Development Team Review Comments

Project Number: RCU2021-00023

Project Name: GCSA Event Center

Commenting Division: Plan Coordination 4th Review

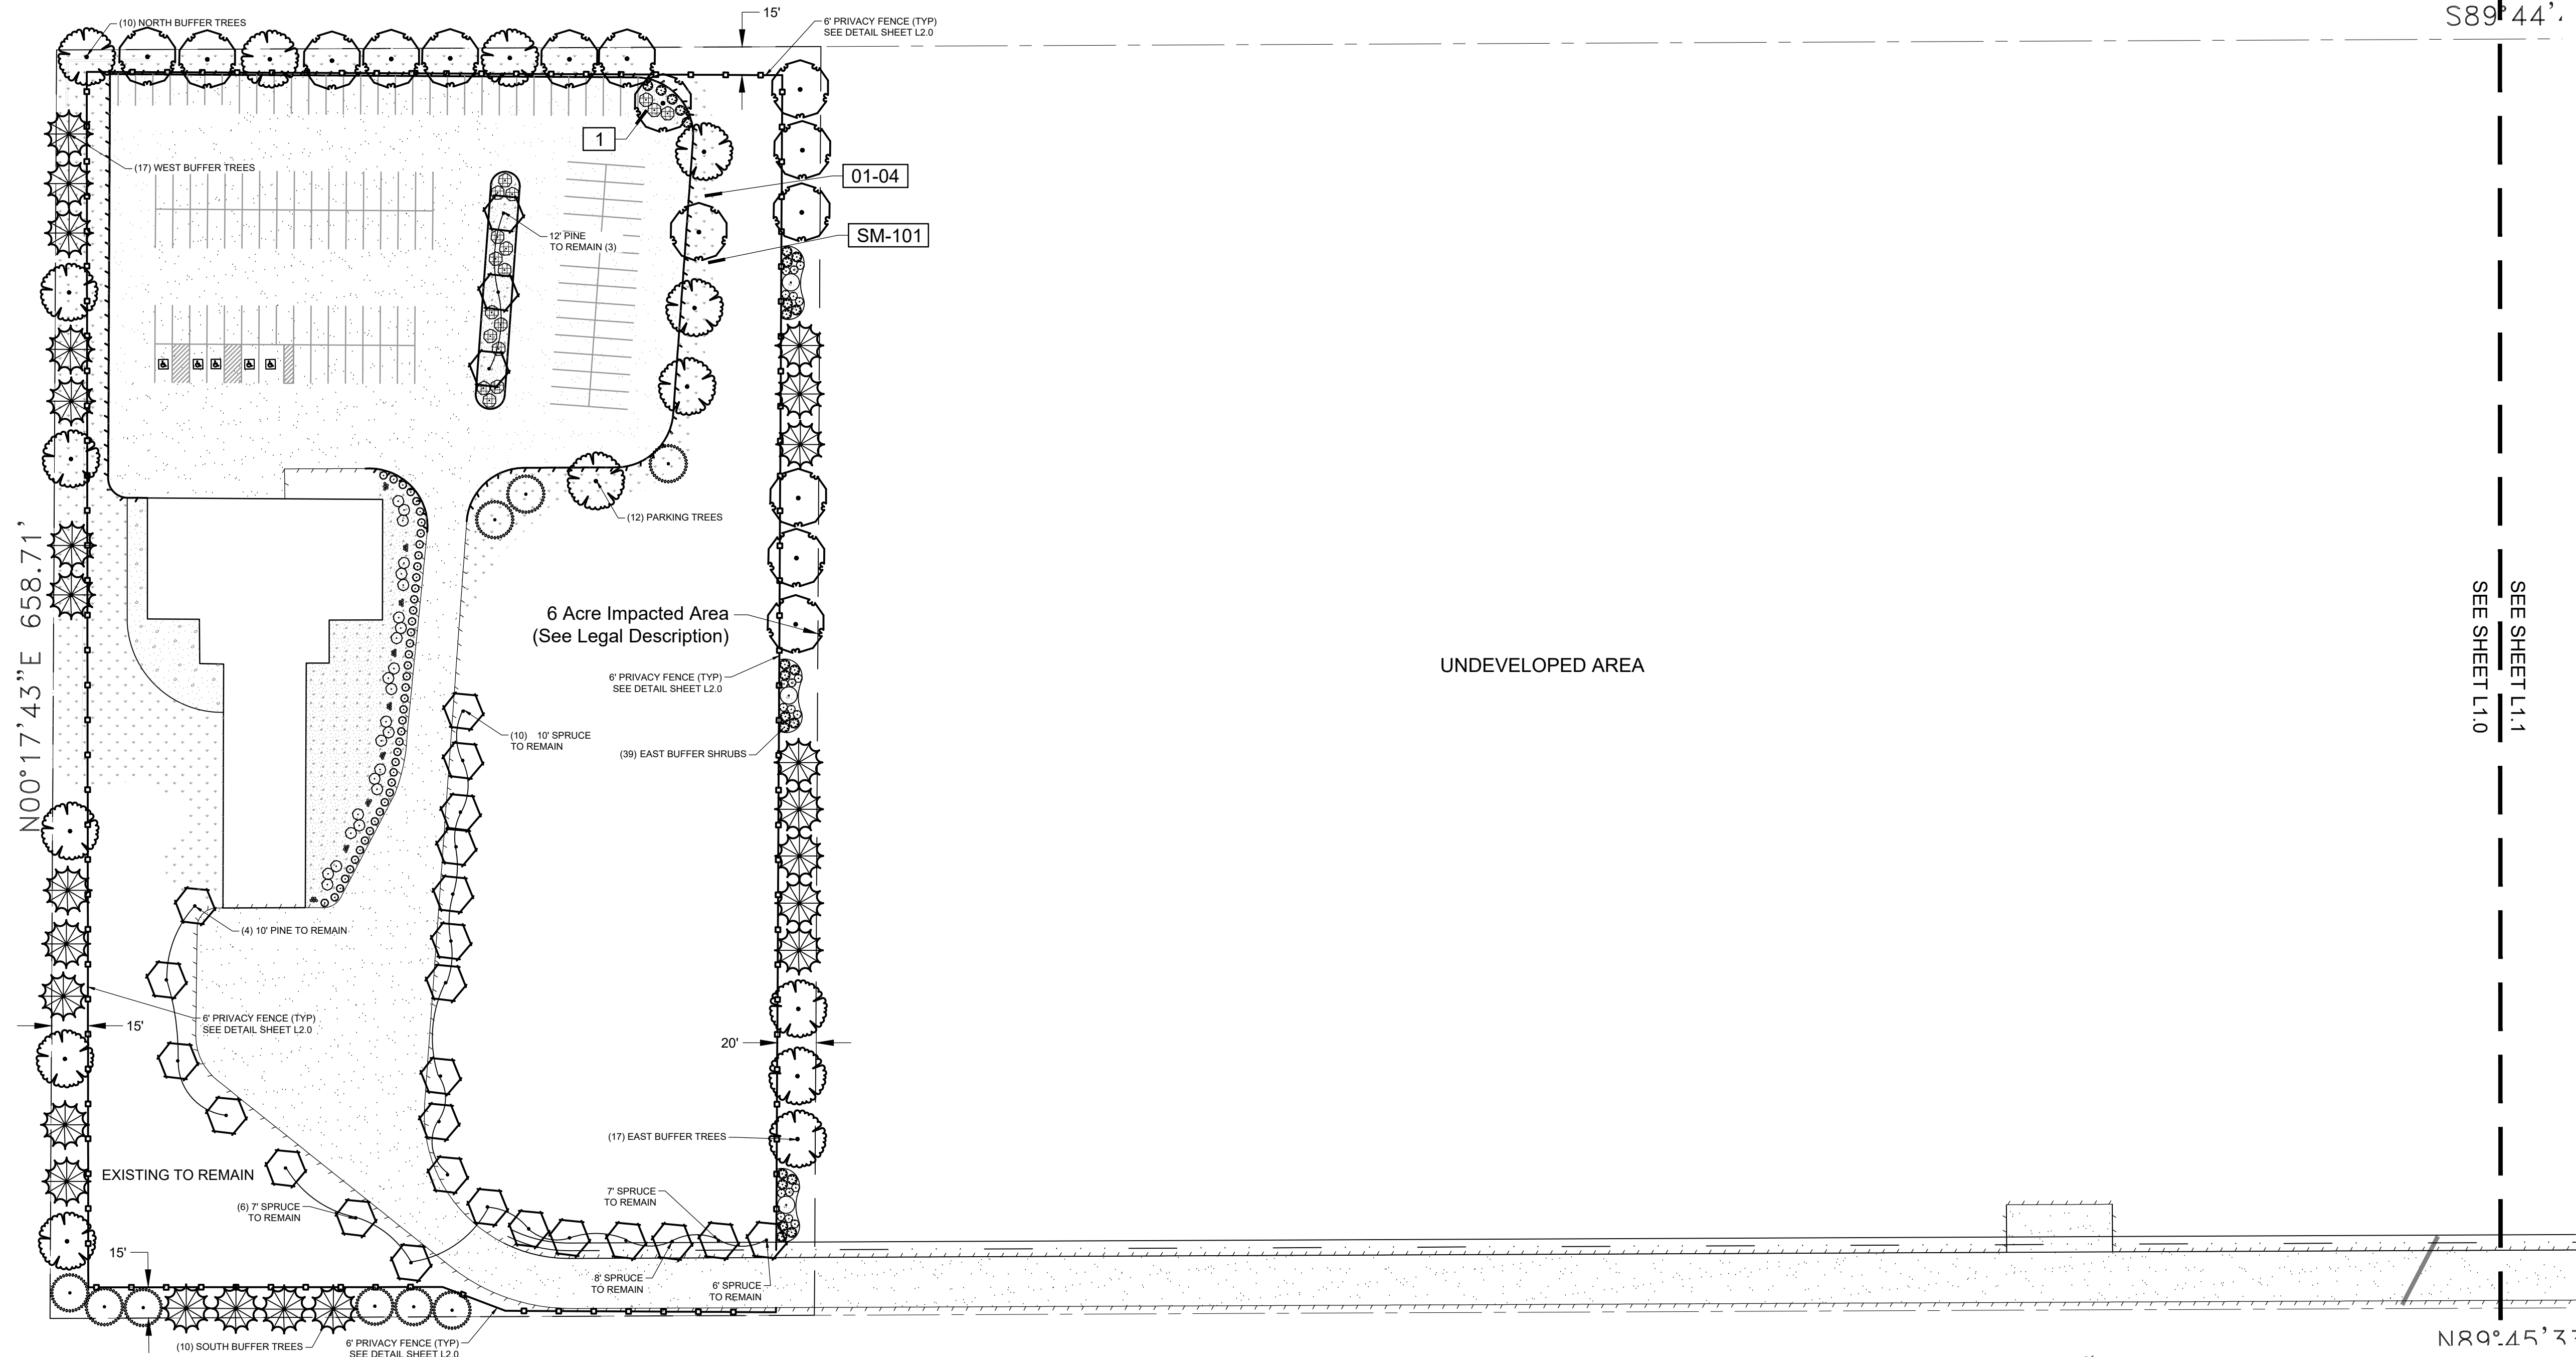
1. Throughout the entire southwest corner of the site, where there is space between the fence and the property line, there needs to be the same ratio of trees per foot as the other project site edges.

2. The eastern border of this abbreviated project site area shall have a fence like the other bufferyards. Since the adjacent use to this is agriculture (the rest of the site), the bufferyard must be the same as other site bufferyards.

Landscape plans updated as requested.

Landscape plans updated as requested.
